MEMORANDUM

то:	Board of Mayor and Aldermen
FROM:	Paul Holzen, Director of Engineering Jimmy Wiseman, Assistant Director of Engineering Carl Baughman, Traffic Engineer III Josh King, Senior Planner
SUBJECT:	Ashcroft Valley Development Plan – Recommended Offsite Transportation Improvements

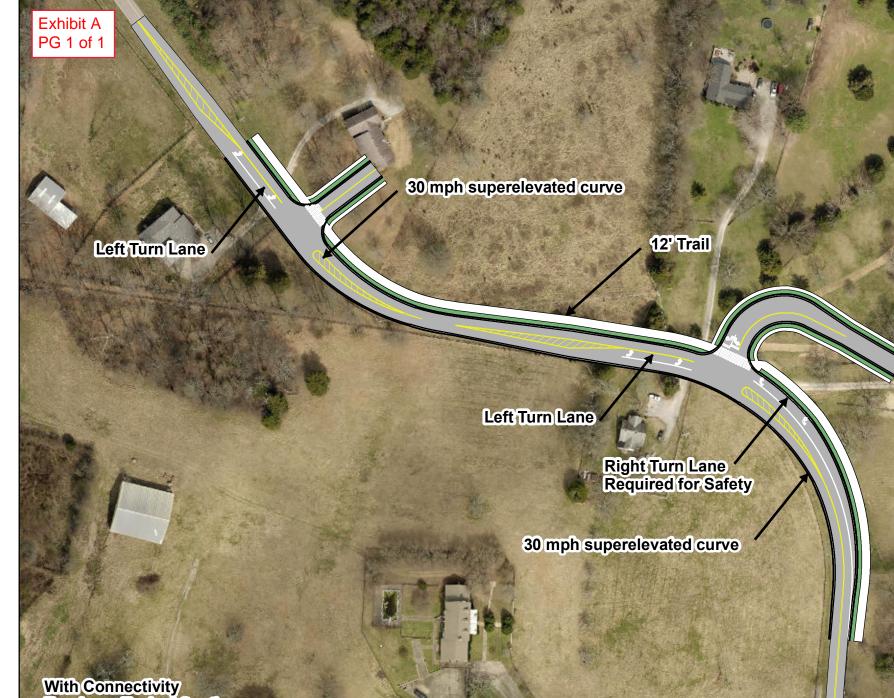
- 3. The western project access on S. Carothers Road should be constructed to include one entering lane and one exiting lane, striped as a shared left and right turn lane. In conjunction with this configuration South Carothers Roadway shall be constructed as a three lane minor collector roadway that would include a left / eastbound turn lane and should include at least 100 feet of storage (See Exhibit B).

- 4. The eastern (main) project access on S. Carothers Road should be constructed to include one entering lane and two exiting lanes, striped as separate left and right turn lanes. This project access shall be constructed with S. Carothers Road to allow free-flowing traffic on S. Carothers Road and the main project access shall tee into S. Carothers Road. S. Carothers Road shall be designed as a three lane minor collector street. The design speed on S. Carothers Road shall be 40 MPH so that it can be posed at 30 mph. Due to limited sight distance a westbound right turn lane shall be added, at the main entrance, on S. Carothers Road to prevent future accidents. In

conjunction with this configuration, a southbound/eastbound left turn lane should be provided on S. Carothers Road at the project access. This turn lane should include at least 100 feet of storage and should be designed and constructed according to AASHTO standards (See Exhibit B).
